Kansas Department of Agriculture
 Division of Water Resources
CHANGE: P/U WORKSHEET

RE: Field Office Application for Change
Water Right, File Nos. 7977, 8739, 18479

DWR FIELD OFFICE APPLICATION FOR APPROVAL TO CHANGE THE PLACE OF USE AND/OR THE POINT OF DIVERSION

CHANGE IN PLACE OF USE WATER RIGHT, FILE NO. 8739

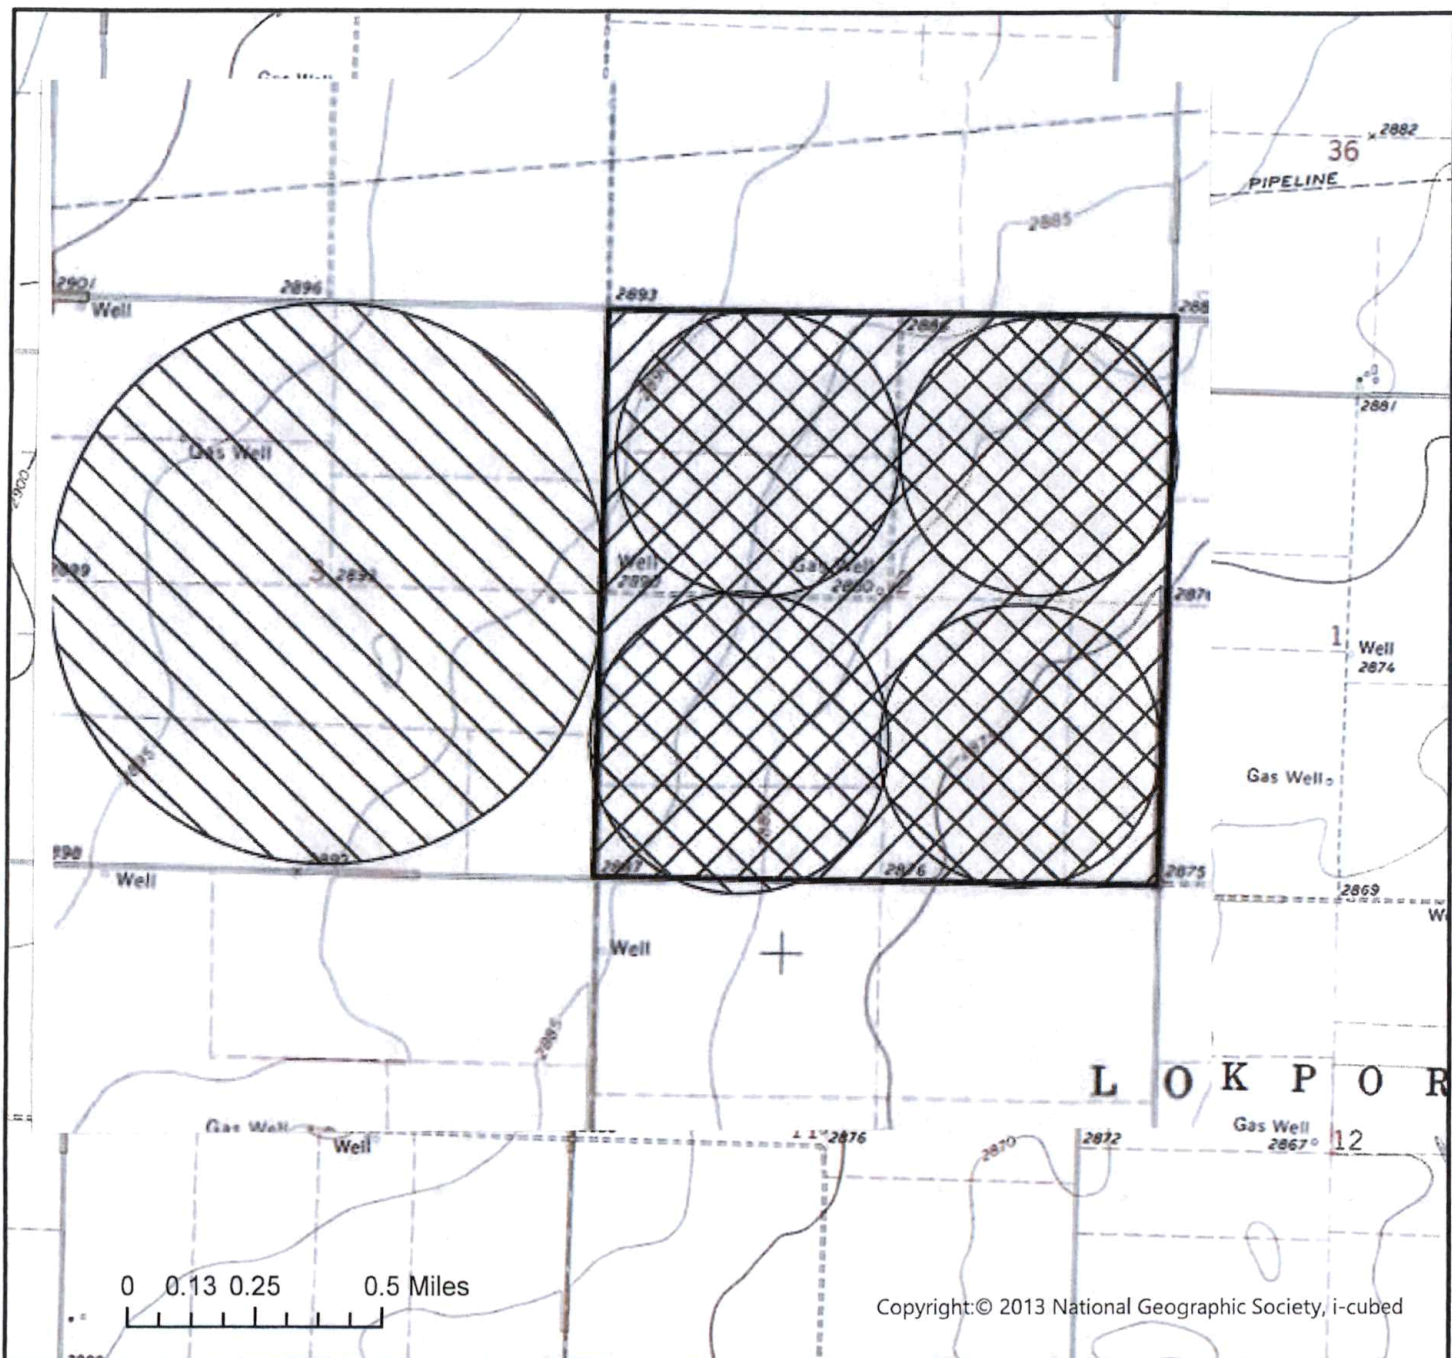
We have reviewed the applications for the above referenced water rights. The proposals are not in conflict with the Management Program of the Southwest Kansas Groundwater Management District No. 3 (GMD3). The proposed change in place of use will eliminate the corners of the pivot systems to better suit the operation and keeps the acres within the allowable range, in accordance with K.A.R. 5-5-11(b). There is a future PD change proposed for one of the wells and the acre feet will be adjusted at that time. At the same time, the water rights will have a complete overlap in place of use. It is therefore recommended that the applications be approved at this time.

500 acres, 3-30-32. Half mile pivot and dropping the corners in the section
500 acres, 2-30-32. Quarter mile pivot (125acres) in each quarter and
dropping the corners.
Combined: 2472AF on 1000 acres. 2.472AF/acres

Is a waiver needed: No new acres being proposed and will make a complete overlap on all three water rights.

Recommendation: After review of all information, it appears to meet current area rules. We will be working the PD change as soon as we get it. Staff recommends approval of the application.
